Service Bulletin No. 403

MODEL	J4500 Series	TYPE	Field Change Program	SECTION/GROUP	3-Body	DATE	Mar. 18, 2014
SUBJECT	DD13 DPF CRADLE						
CONDITIONS

Figure 1.

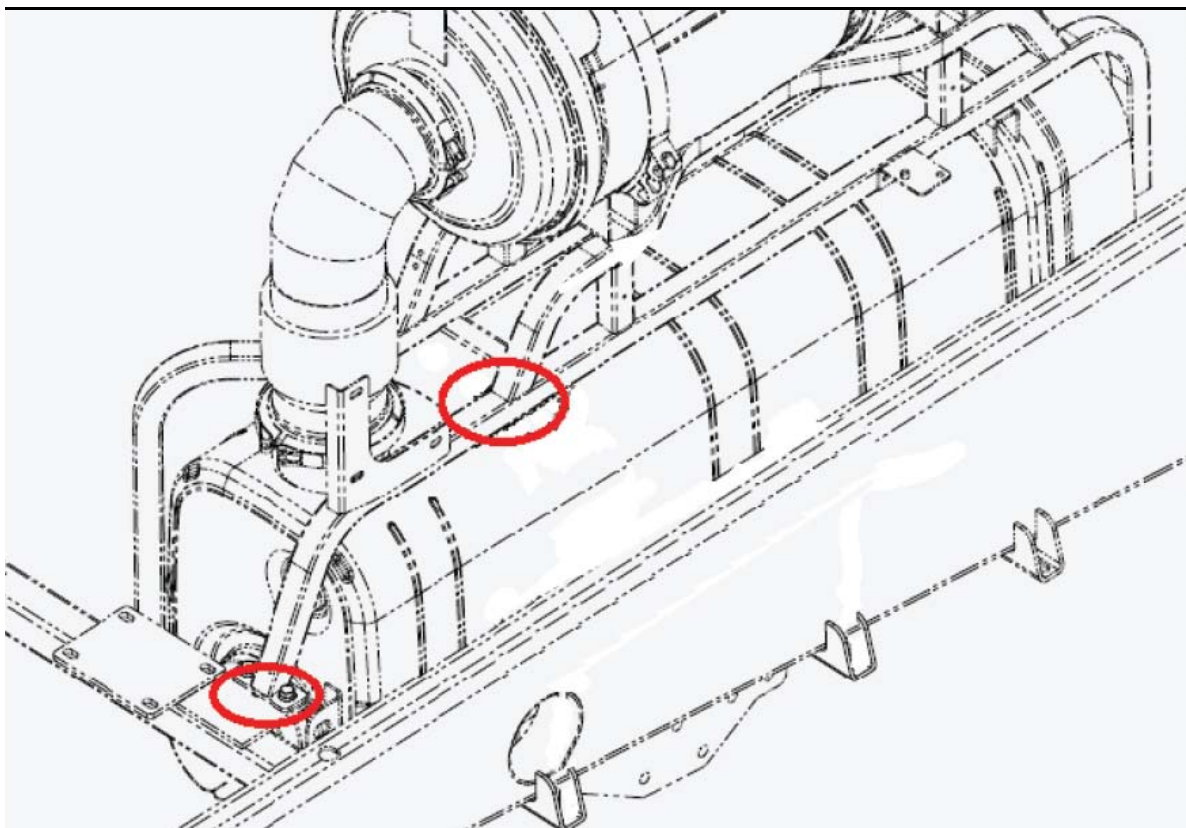
Visually inspect the two (2) areas circled in Figure 1.

Upon visual inspection, if signs of cracking are evident at one or both locations identified in Figure 1, contact the MCI Fleet Support Technical Center at 1-800-241-2947 for further information.

Figure 5.

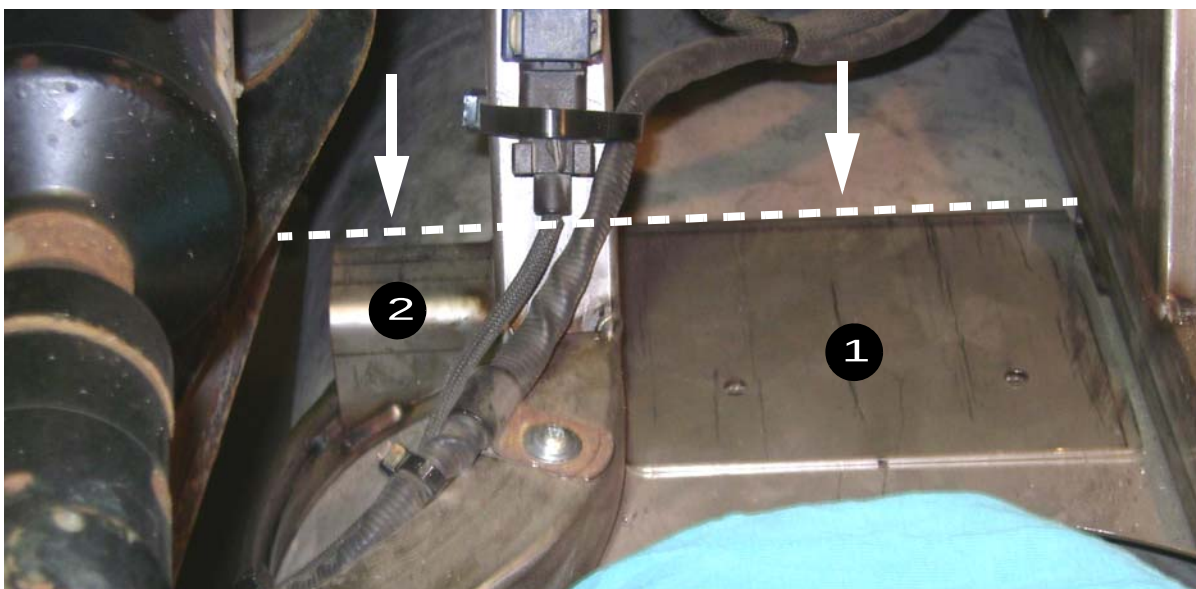
9. Orient the drill template, p/n 20-08-0045, over the back end of the tubing shown in Figure 5. Pull template against the tubing, ensuring there is no gap.

Figure 8.

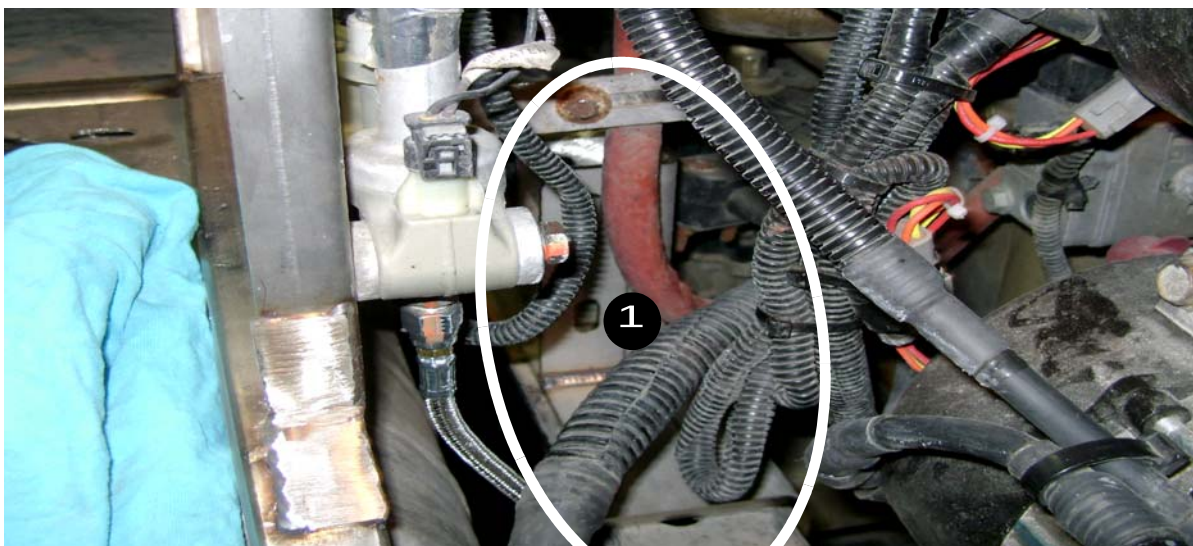
12. Align and position the bracket, p/n 08-20-2421, on the engine rail. Move any interfering hoses and guide the bracket along the engine rail, forward towards the front of the coach. Align with the reamed holes drilled in Step 11.

Figure 9.

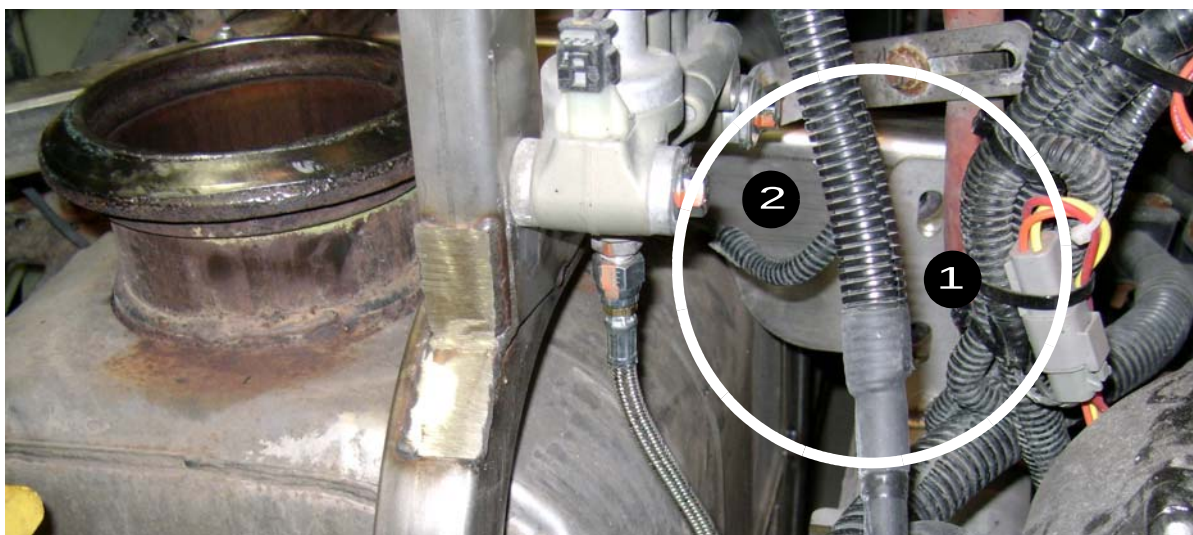
13. Align the channel, p/n 08-20-2418, (part with tapped holes) with the bracket installed in Step 12.

Figure 10.

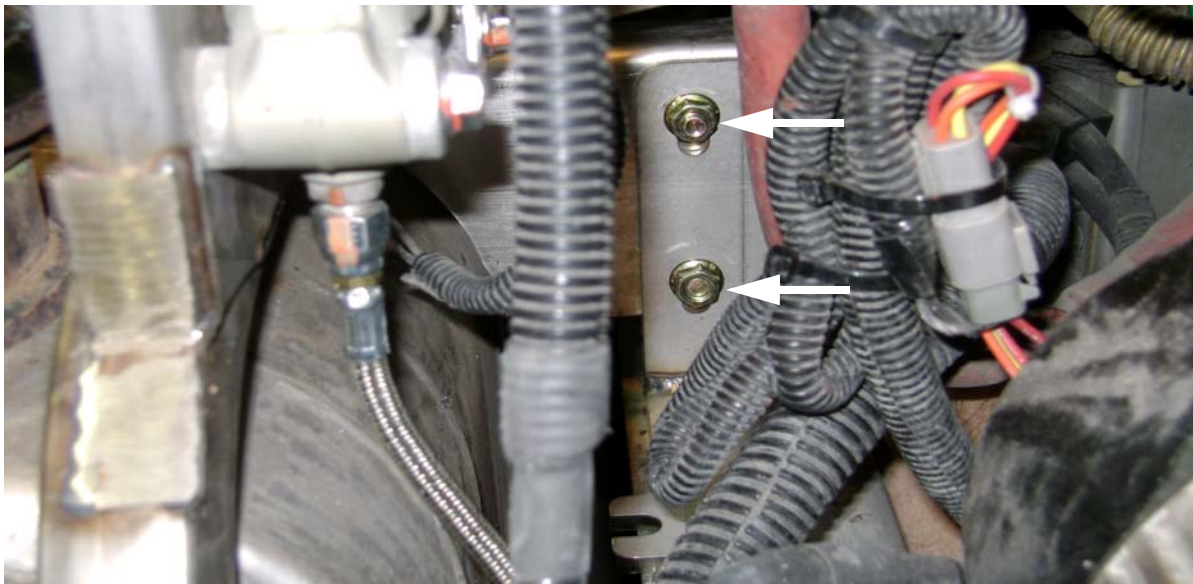
14. Using two (2) capscrews, p/n 19-01-2122 and locknuts, p/n 19-03-0535, secure the channel to the bracket finger-tight (refer to Figure 10). Align the channel-bracket assembly with the slotted holes shown in Figure 11. Torque to 42-48 ft-lbs.

Figure 13.

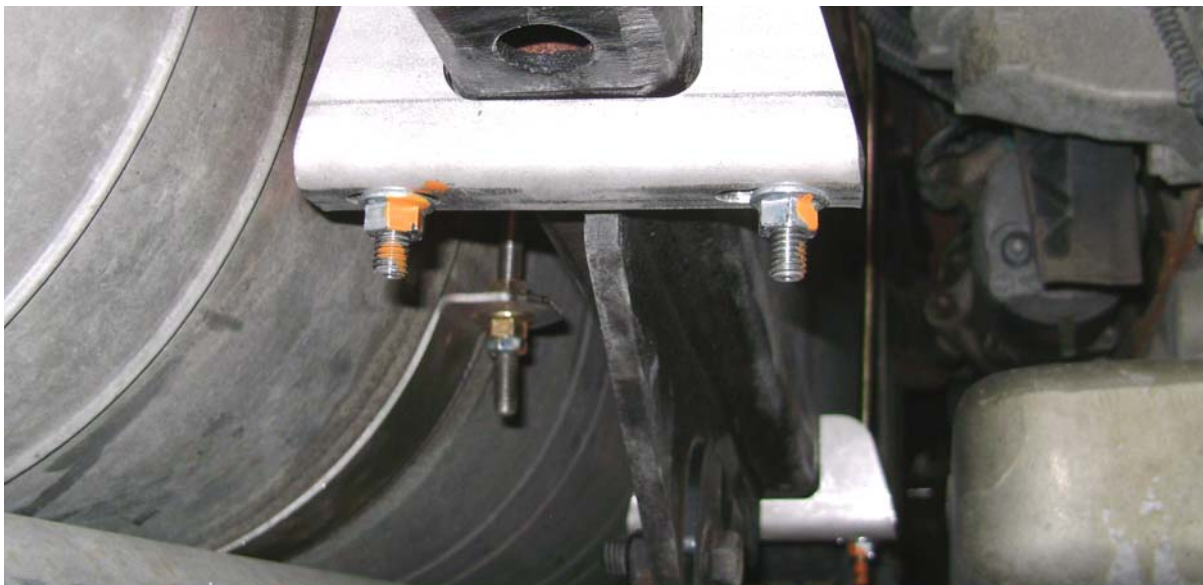
16. Torque capscrews to 25-30 ft-lbs. Apply torque seal to the face of the capscrews.
17. Orient the u-bolts, p/n 08-20-2424 and 2425, on the bracket and engine rail as shown in Figures 13 and 14.

Note the taper on the two (2) u-bolt brackets, p/n 08-20-2426. Orient the brackets with the low side of the taper facing the front of the coach, ensuring proper installation mating with the slope of the engine rail.

Figure 14.

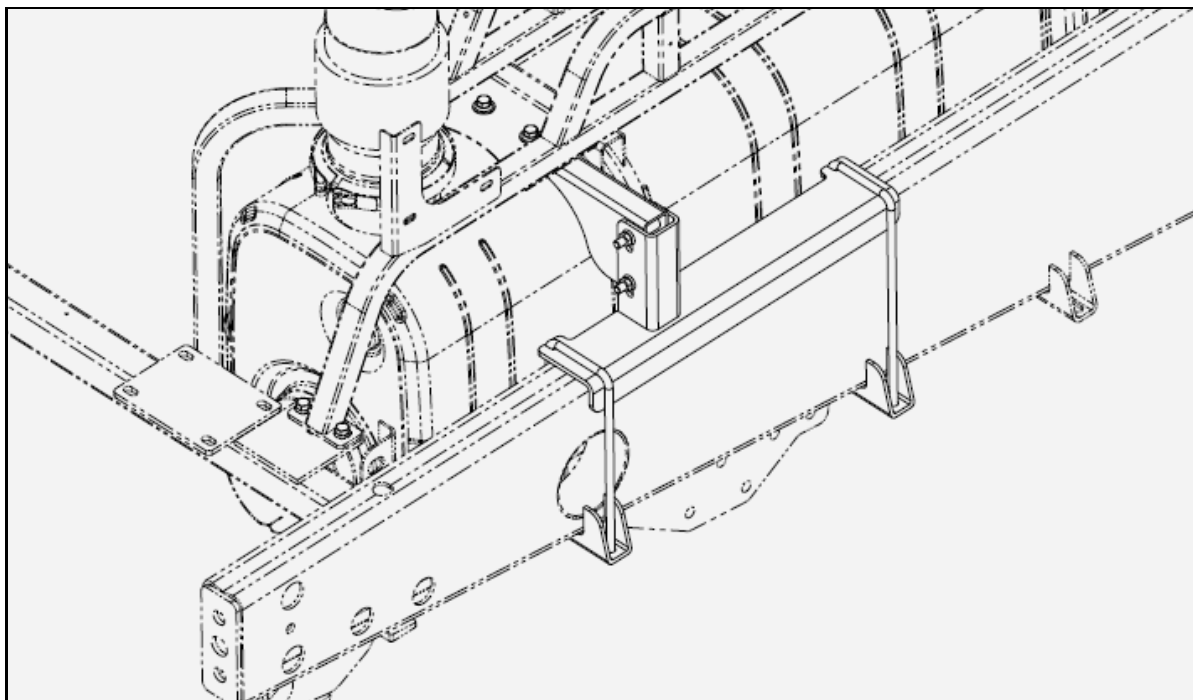
18. Using the u-bolts, brackets, p/n 08-20-2426, and locknut, p/n 19-03-0535, secure bracket to the engine rail. Torque to 25-30 ft-lbs. Apply torque seal to the face of the nuts.
